SUNDRY NOTICES AND REPORTS ON WELLS

8. Well Name and No.
PEACHES 19 FEDERAL 4H

OXY USA Inc. respectfully requests approval for the following changes to the drilling plan:

PECOS DISTRICT
CONDITIONS OF APPROVAL

5M BOP Stack

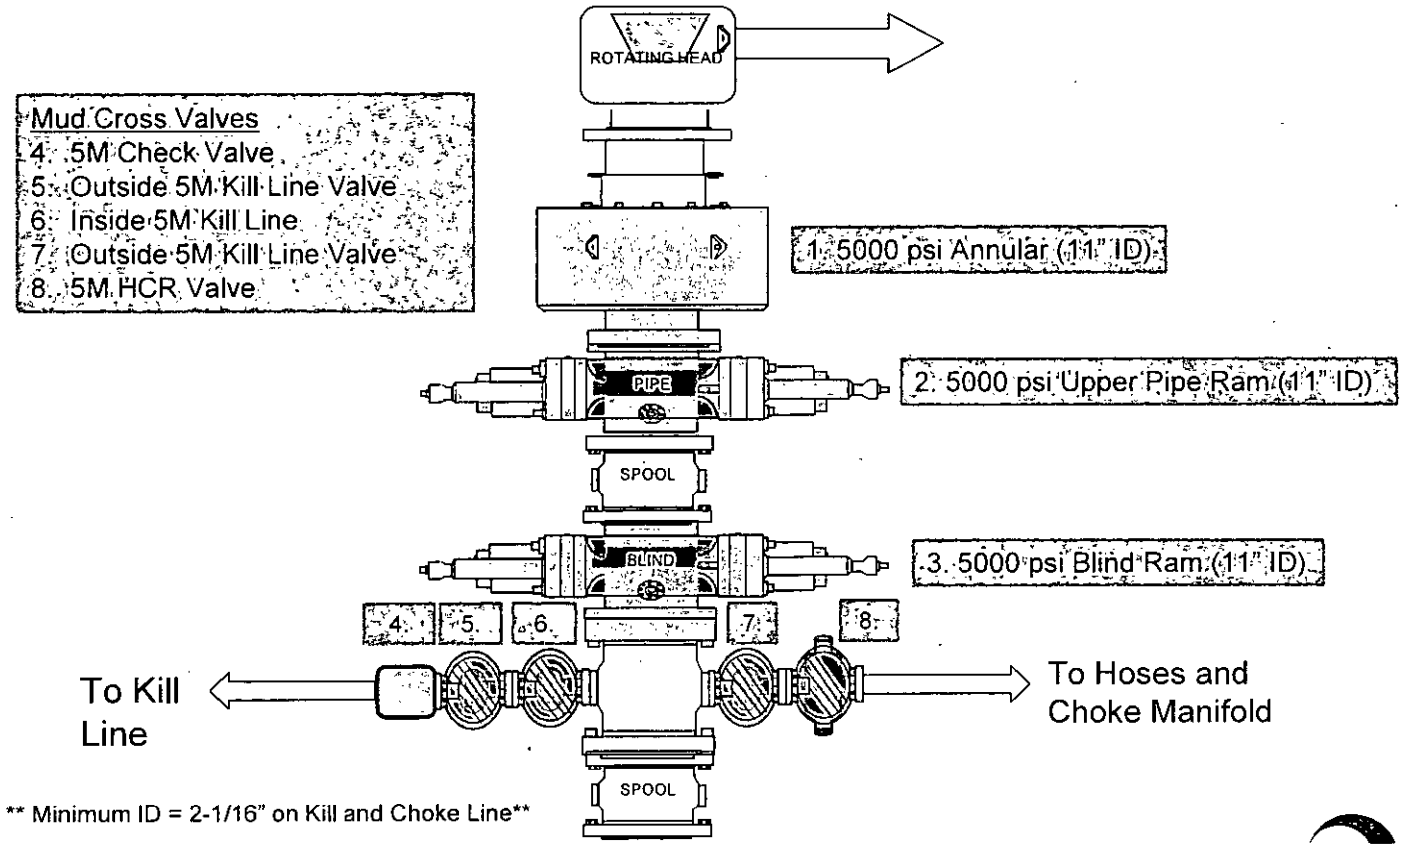
4. The Operator will connect the BOP choke outlet to the choke manifold using a hose that meets all BLM requirements and will be inspected and approved by BLM personnel prior to spud.

2. Variance approved to use flex line from BOP to choke manifold. Check condition of flexible line from BOP to choke manifold, replace if exterior is damaged or if line fails test. Line to be as straight as possible with no hard bends and is to be anchored according to Manufacturer's requirements. The flexible hose can be exchanged with a hose of equal size and equal or greater pressure rating. **Anchor requirements, specification sheet and hydrostatic pressure test certification matching the hose in service, to be onsite for review. These documents shall be posted in the company man's trailer and on the rig floor.** If the BLM inspector questions the straightness of the hose, a BLM engineer will be contacted and will review in the field or via picture supplied by inspector to determine if changes are required (operator shall expect delays if this occurs).

3. **Operator has proposed a multi-bowl wellhead assembly. This assembly will only be tested when installed on the surface casing. Minimum working pressure of the blowout preventer (BOP) and related equipment (BOPE) required for drilling below the surface casing shoe shall be 5000 (5M) psi (Installing 10M testing to 5,000 psi).**

5M system requires an HCR valve, remote kill line and annular to match. The remote kill line is to be installed prior to testing the system and tested to stack pressure.
